PLANNING BOARD MEETING

Tuesday, March 26, 2024 at 6:00 PM

1. 43 Scanlon Drive - Site Plan & Design Review (continuation at 6:15pm)

Short Street - Site Plan and Design Review

• Five (5) copies of revised architectural plans sheet A-201 prepared by Stantec Architecture & Engineering P.C. and dated October 6, 2023 with revisions through March 26, 2024;

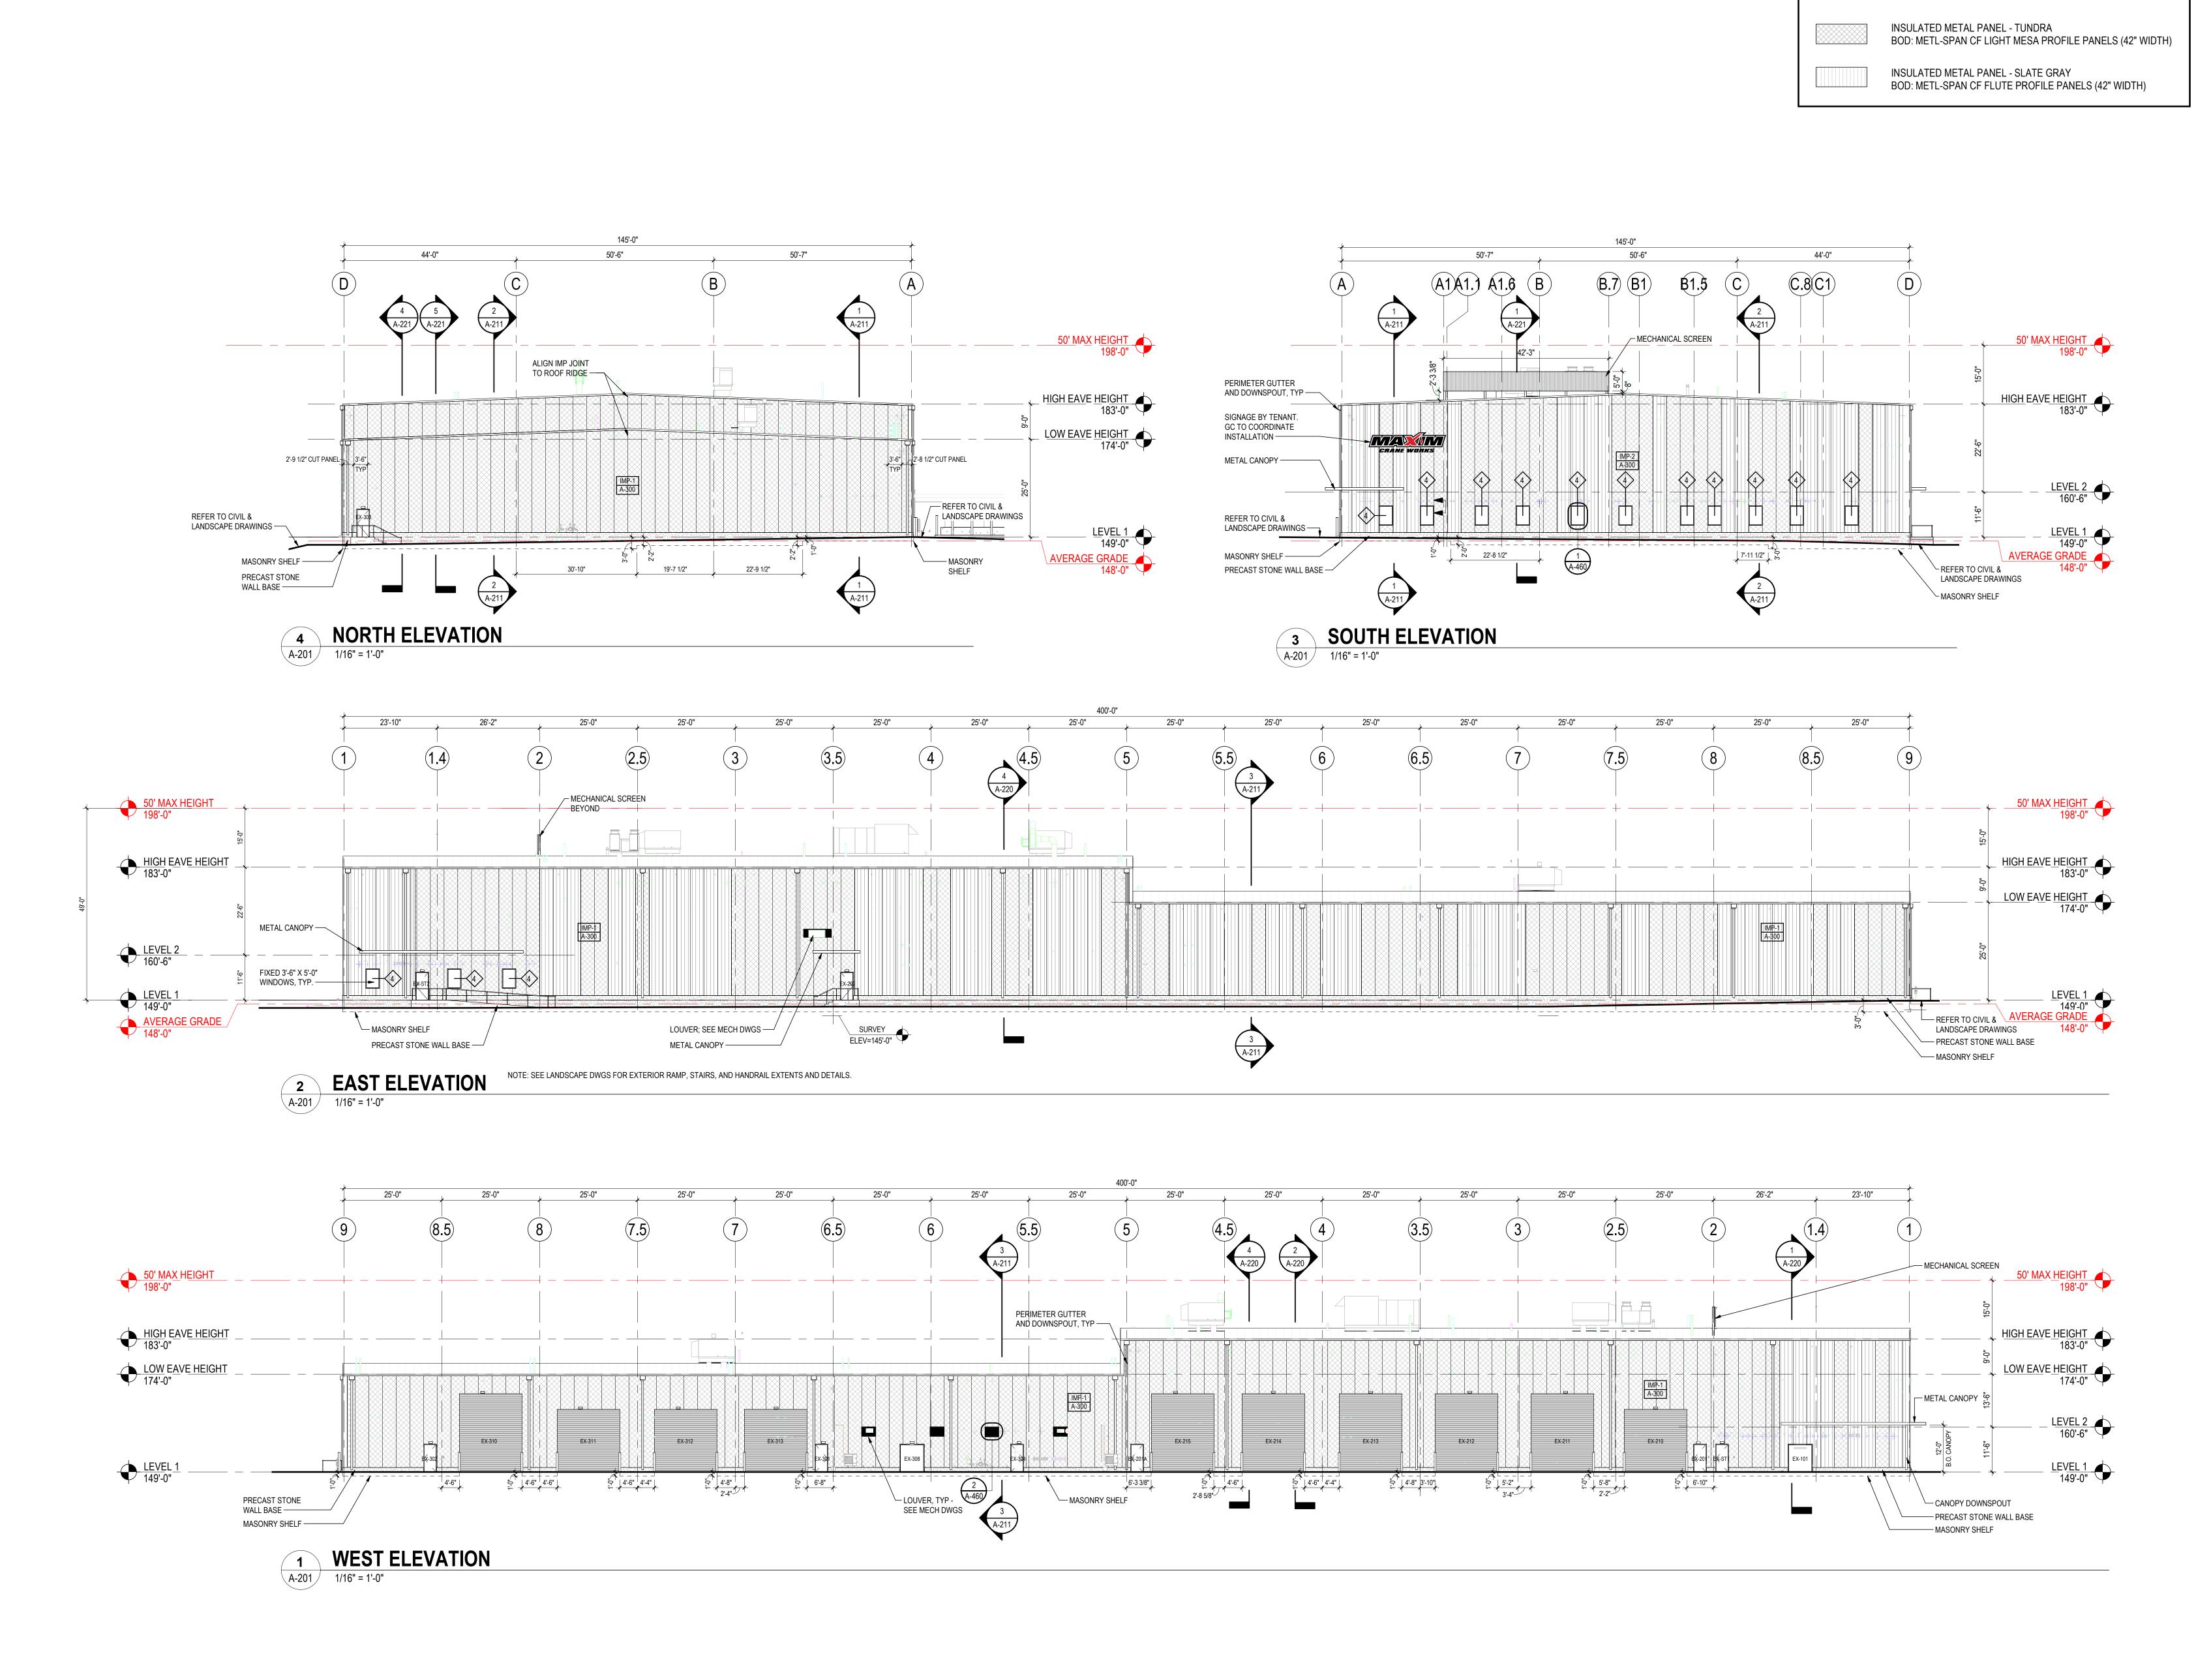
Chairman Plizga requested that Mr. Kadish update drawing A-201 to show the awning and canopy and the parapet on the south elevation (east and west elevations and cross view).

Chairman Plizga indicated that he intends to make a motion for the project at hearing. Chairman Plizga would like the applicant to address the parapet and awnings and canopies on the east side at the next hearing.

The attached documents address comments made by the Planning Board at the March 12, 2024 public hearing. Modifications to the plans are limited to adding screening to roof to shield the view of rooftop equipment from the adjacent roadways. The screen, shown on 3/A-301, is on the western side of the roof screening equipment beyond. It spans between grids A1 and B7 along 2. The 'Tundra' color-matched screen is 5' tall held off the roof by +/-18" for snow drift – for a total height of 6'-6". Please find the following attached to this letter:
